Addendum 1

Questions and Answers from Potential Bidders

LGPC New Building Project
IFB's C20190100 and C20190200
March 29, 2019

1 FOUNDATION PLAN
1/4" = 1'-0"

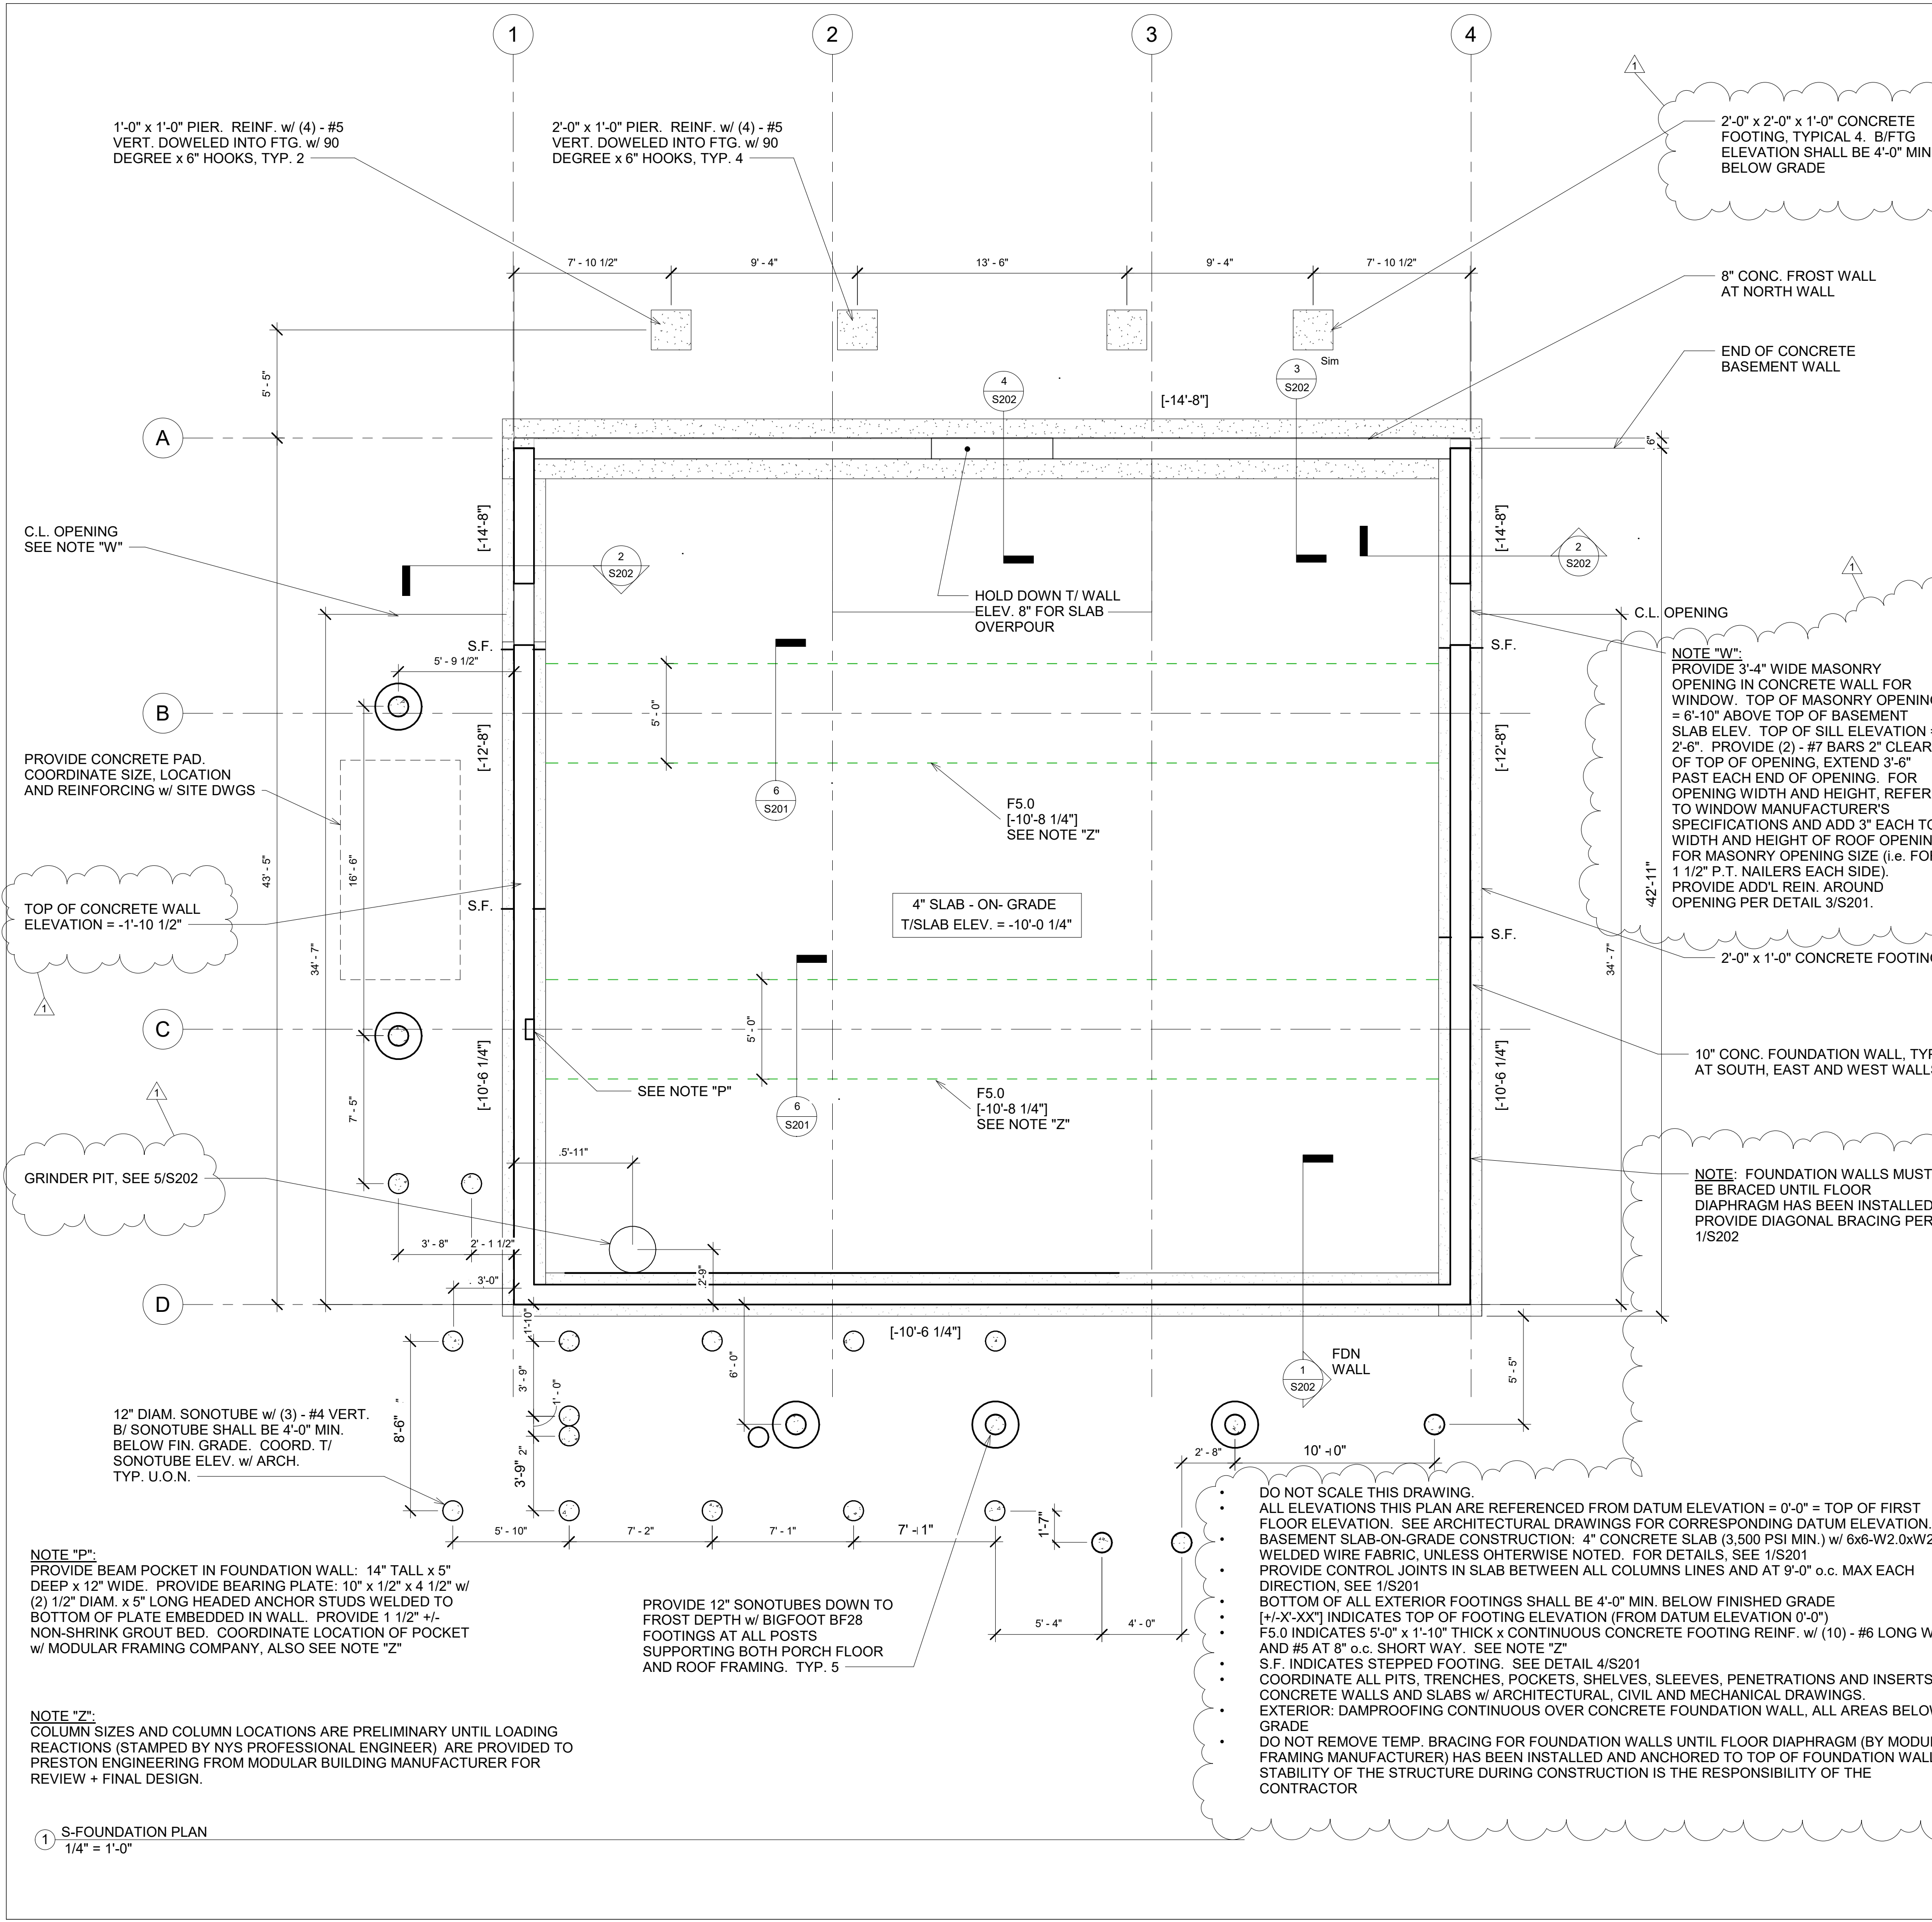
29. S101 – 2'x2'x1' concrete footing, Typical 6...Only 4 on plan?

Change to "TYPICAL 4" – (Note: These are the exterior footings)

1 FDN WALL SECTION 1
3/4" = 1'-0"

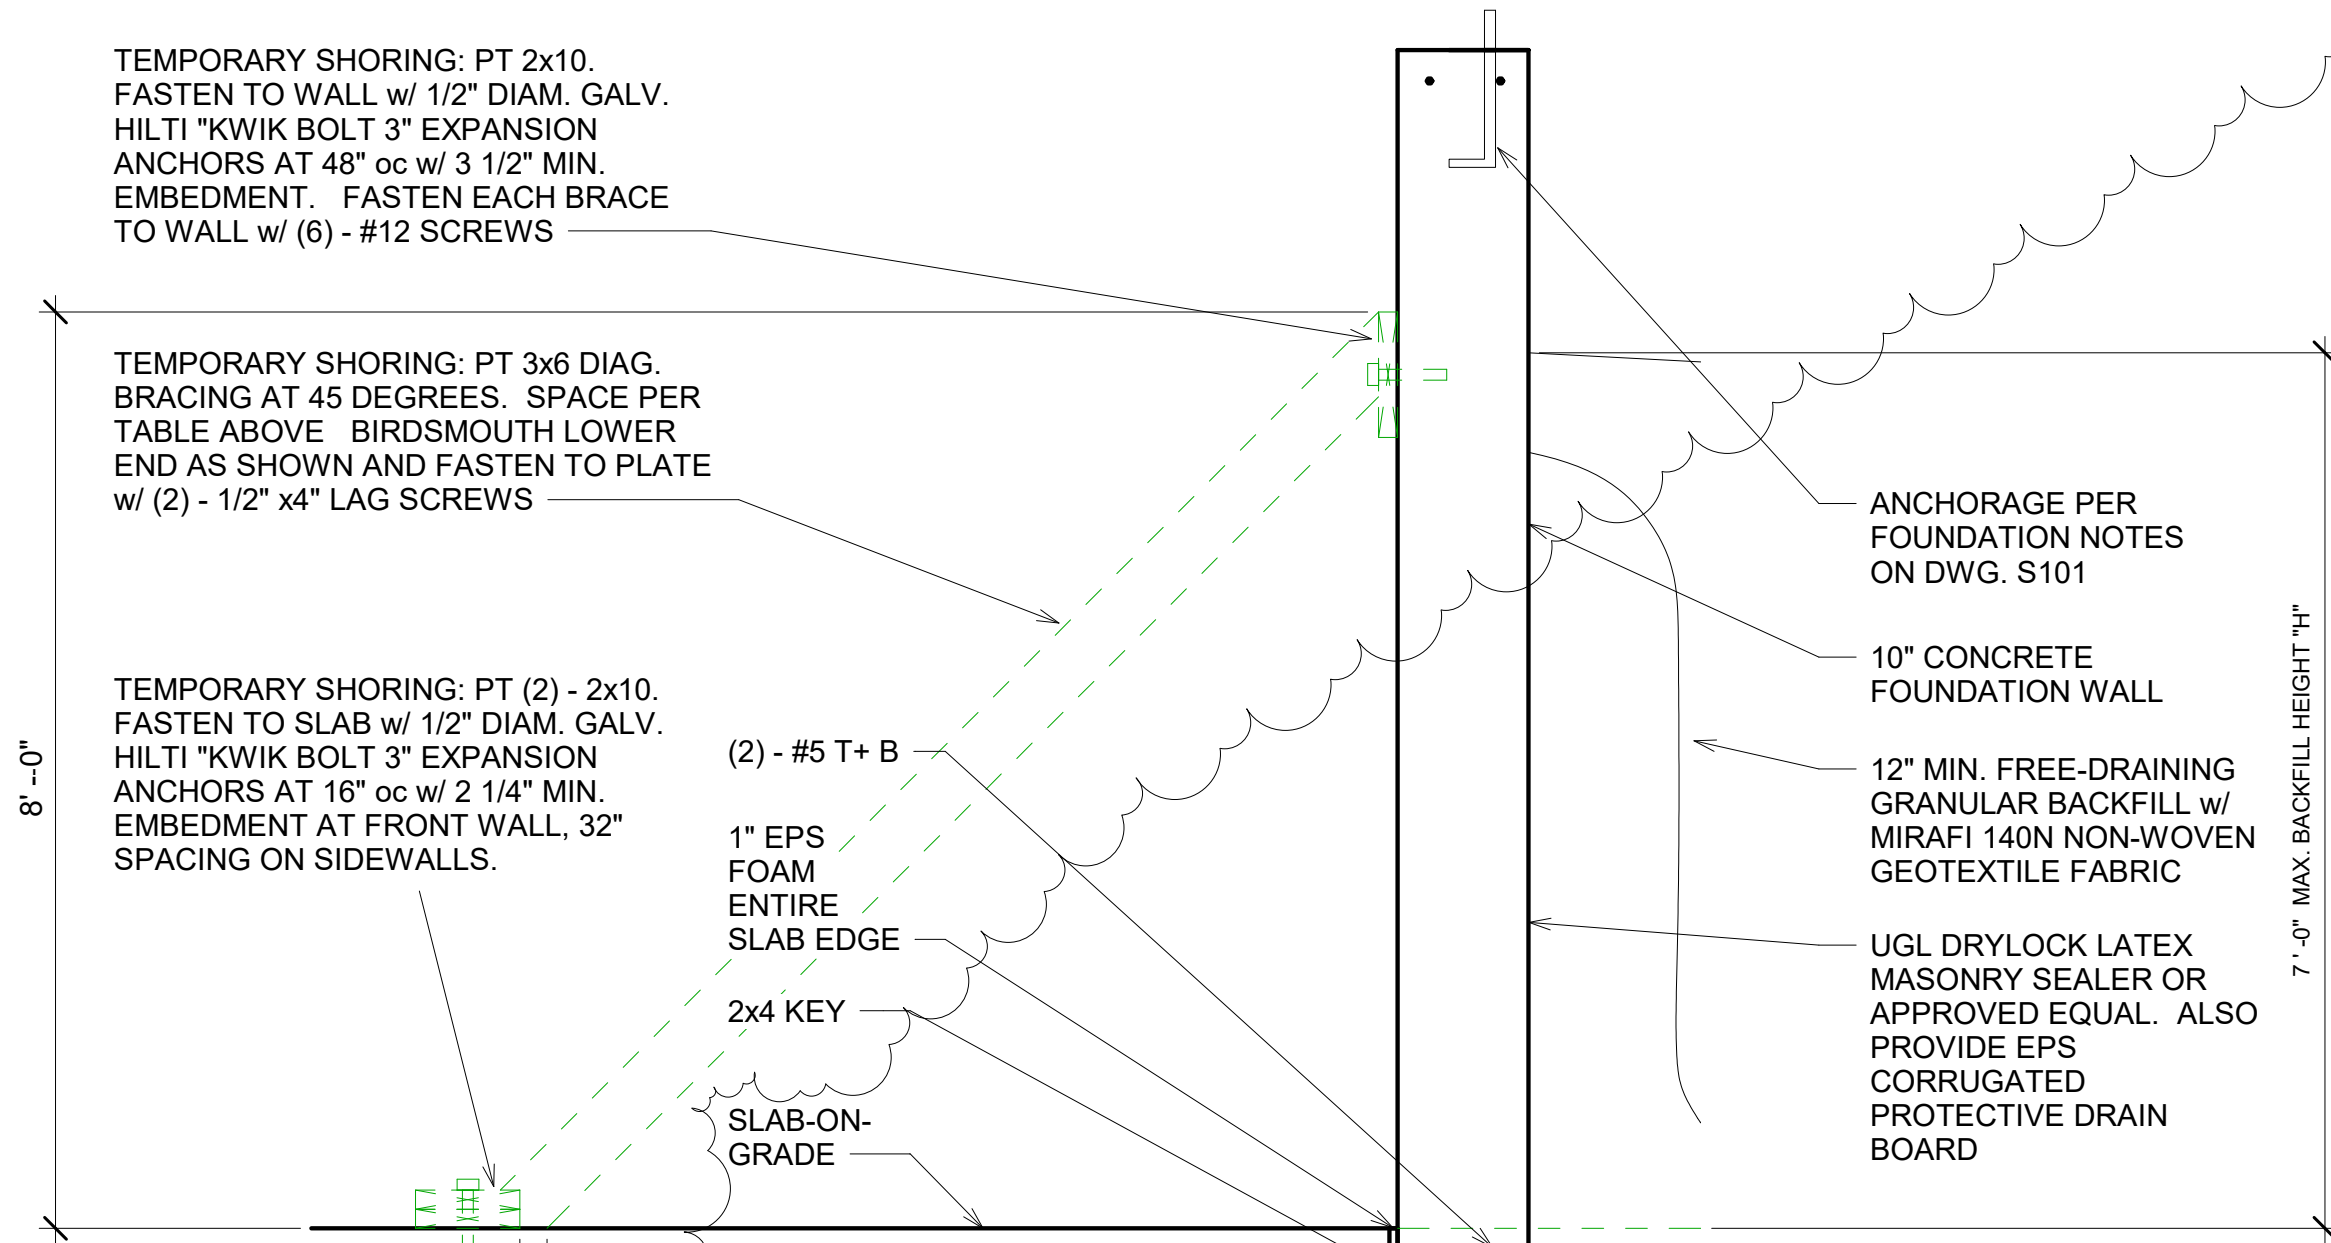
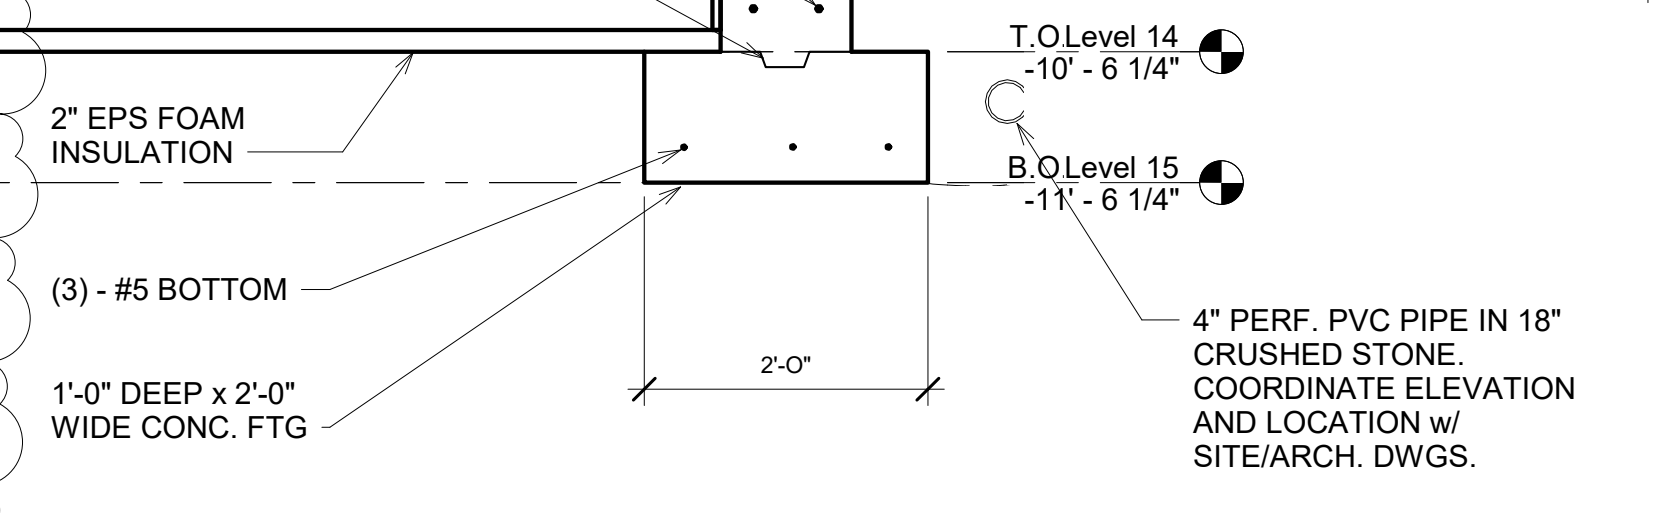
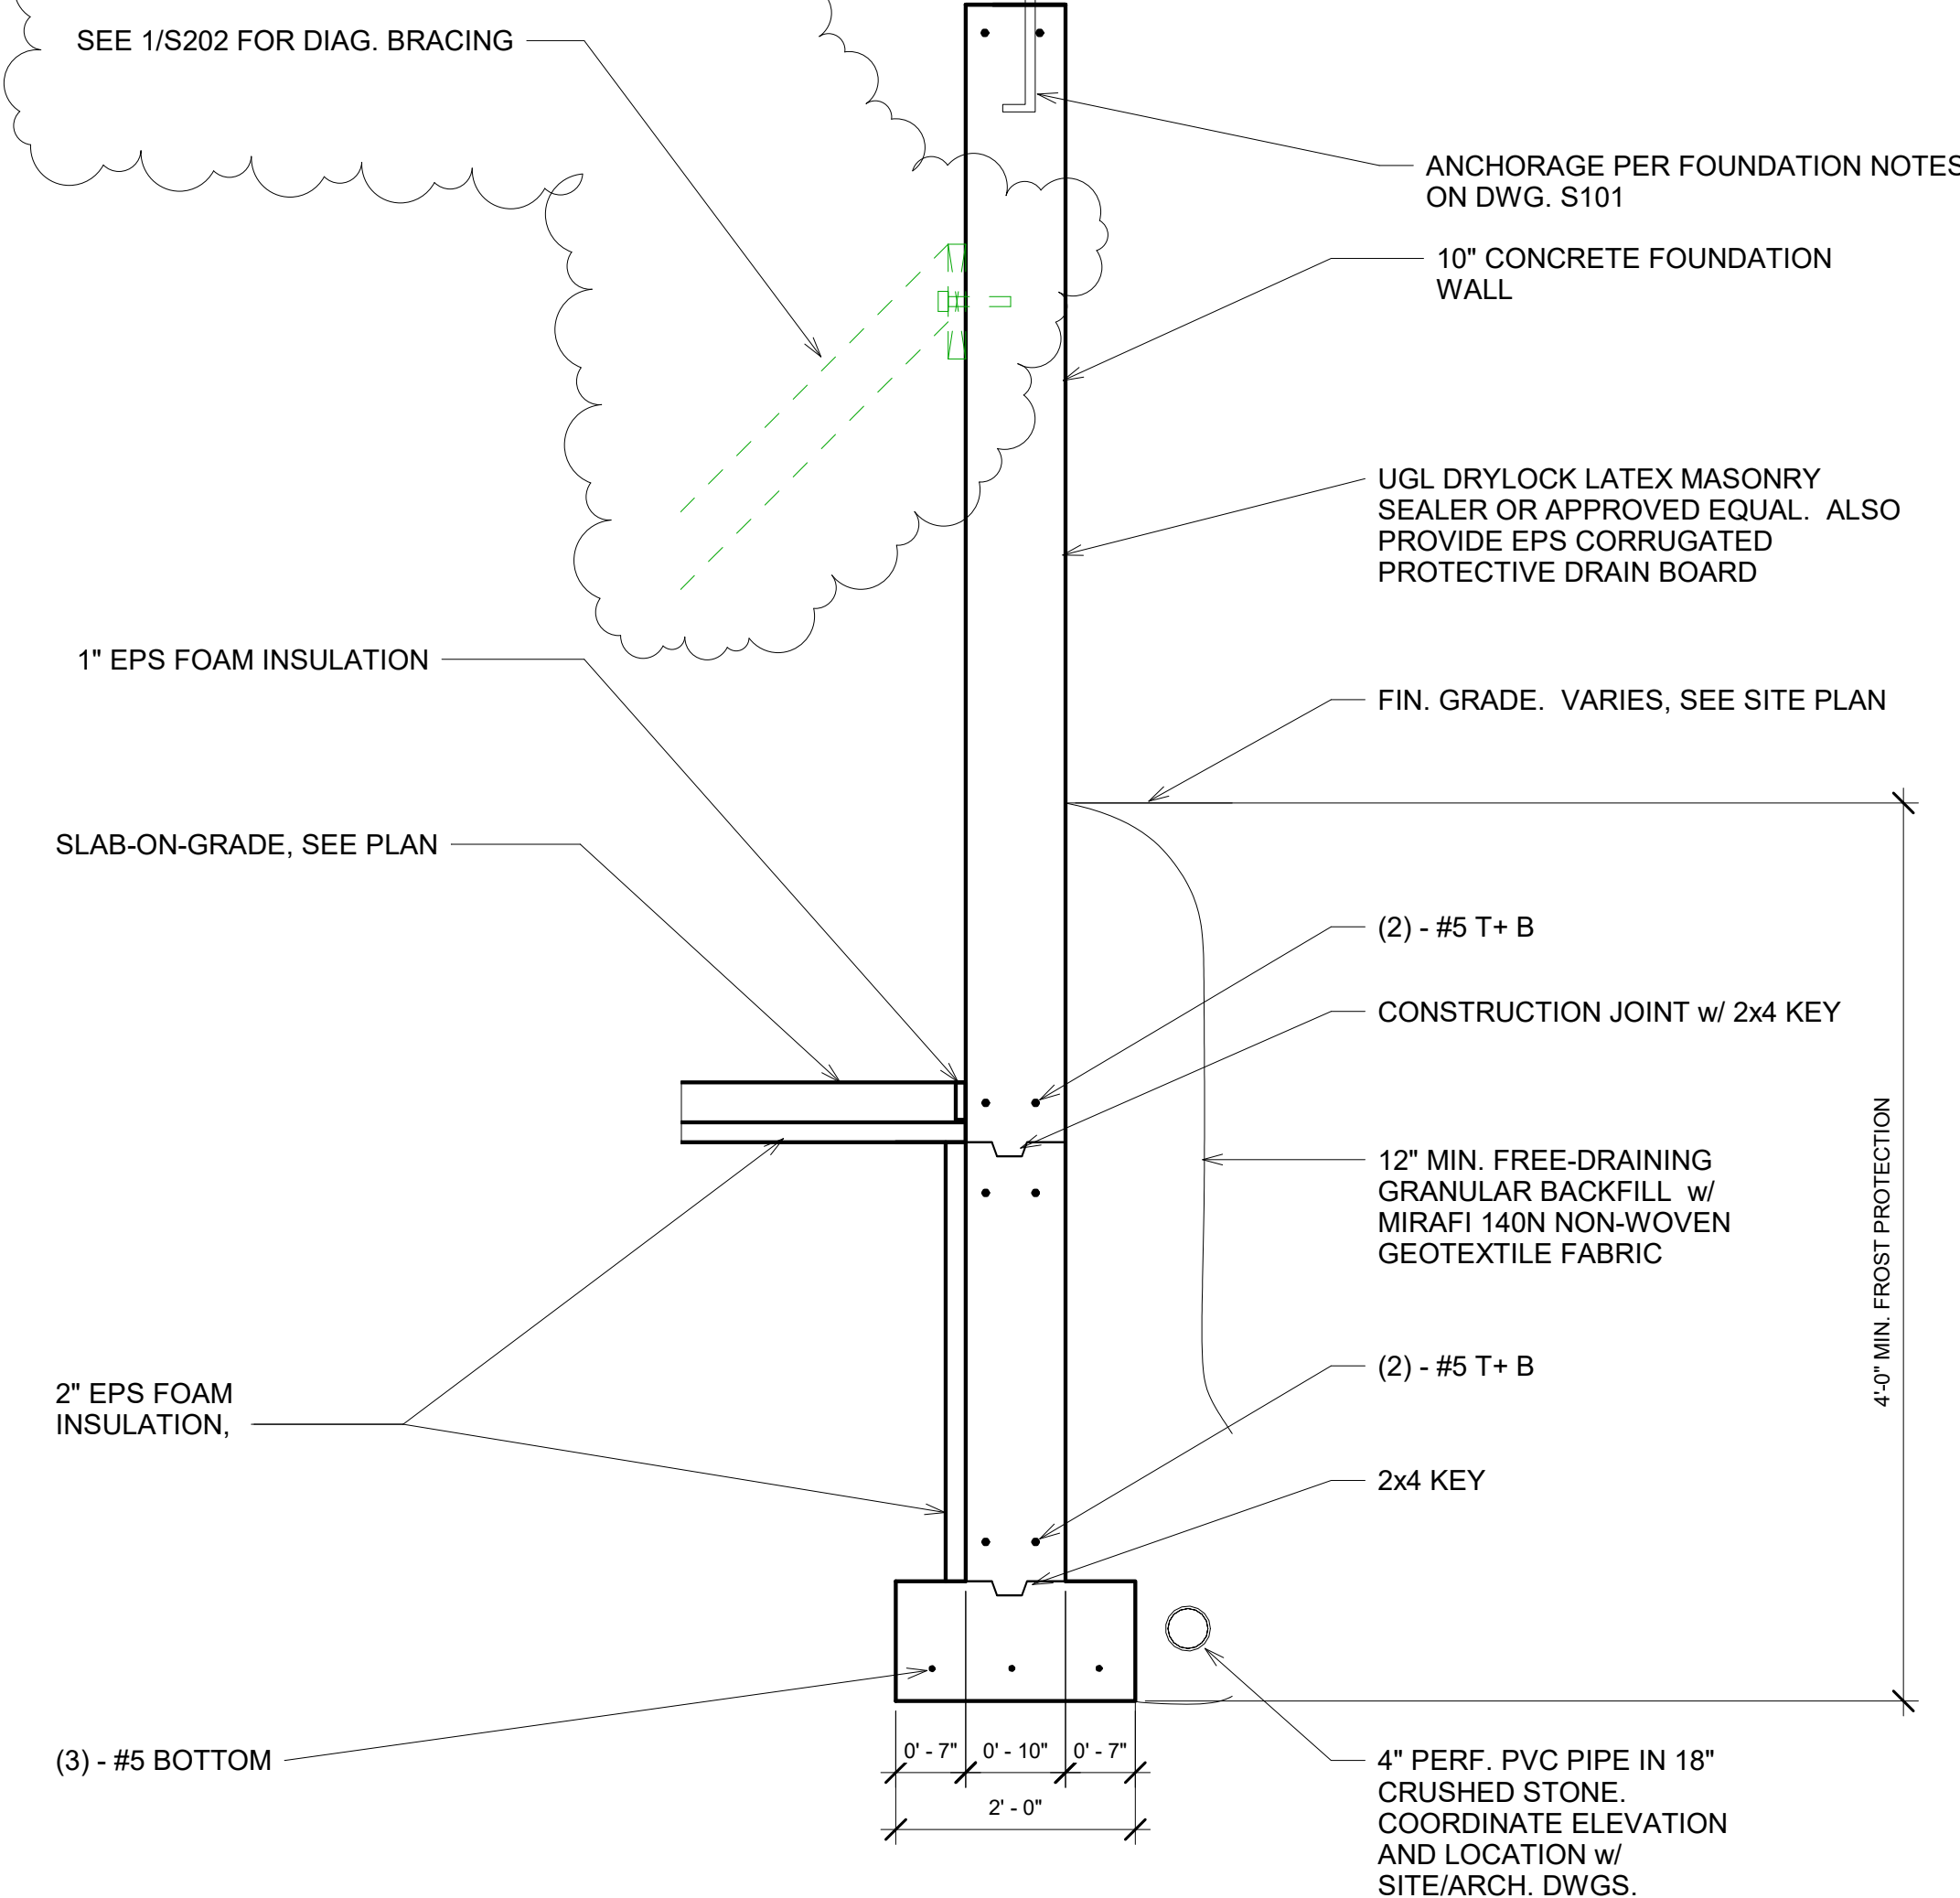
27. Is there a schedule for installation of floor diaphragm? Is this a complete cover or bracing? Can you provide details for the installed diaphragm as backfill operations could be influenced by its lay-out.

See attached structural drawing updates for foundation wall bracing guidelines. Bracing to be part of Contract A, and installed prior to back-fill.
